APPLICATION NO.	FILING DATE	FIRST NAMED INVENTOR	ATTORNEY DOCKET NO.	CONFIRMATION NO.
09/856,175	06/04/2001	Hiromu Ueshima	100341-00008	9628
4372	7590	03/20/2008		
ARENT FOX LLP 1050 CONNECTICUT AVENUE, N.W. SUITE 400 WASHINGTON, DC 20036			EXAMINER PAPPAS, PETER	
			ART UNIT	PAPER NUMBER
			2628	
			NOTIFICATION DATE	DELIVERY MODE
			03/20/2008 ELECTRONIC

Office Action Summary

DETAILED ACTION

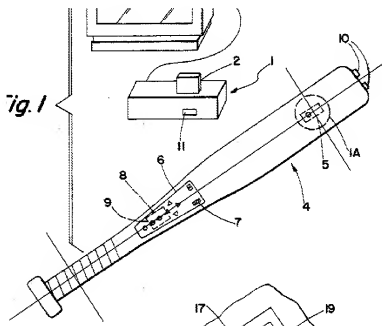
Lipps et al. teaches that the batter's swing is sensed via a centrifugal switch and the appropriate signals are transmitted to a game system. When the bat is swung, the centrifugal force (acceleration correlated signal) causes a weight to move toward a switch. At swing speeds faster than some critical speed, the weight has enough force to actuate the switch (col. 5, lines 58-67; col. 6, lines 12-26). It is noted that the respective claim language fails to disclose what exactly constitutes a "main surface" and therefore

the exterior surface of said switch is considered to read on a "main surface." Thus, it is noted that the main surface of said switch is considered to be both parallel and perpendicular (only one of which is required by the respective claim language) to the longitudinal direction of said grip (Fig. 1, illustrated below, has been modified to more clearly illustrate the relationship between the switch and the grip).

It is noted that the respective claim language discloses "...a main surface of said piezoelectric buzzer is perpendicular to or in parallel with a longitudinal direction of the grip..." Said claim language fails to disclose what exactly constitutes a "main surface" of said switch/buzzer. Therefore, the exterior surface of said switch/buzzer is considered to read on a "main surface." The longitudinal direction of said grip is considered to run in parallel with the longitudinal direction (main surface – e.g., the widest section) of said switch/buzzer. In addition, the longitudinal direction of said grip is considered to run perpendicular to the latitudinal direction (main surface – e.g., the thinnest section) of said switch/buzzer. It is further noted that only one of said two conditions (parallel and perpendicular) is required to be met to address the respective claim limitations. This requirement is considered to be met.
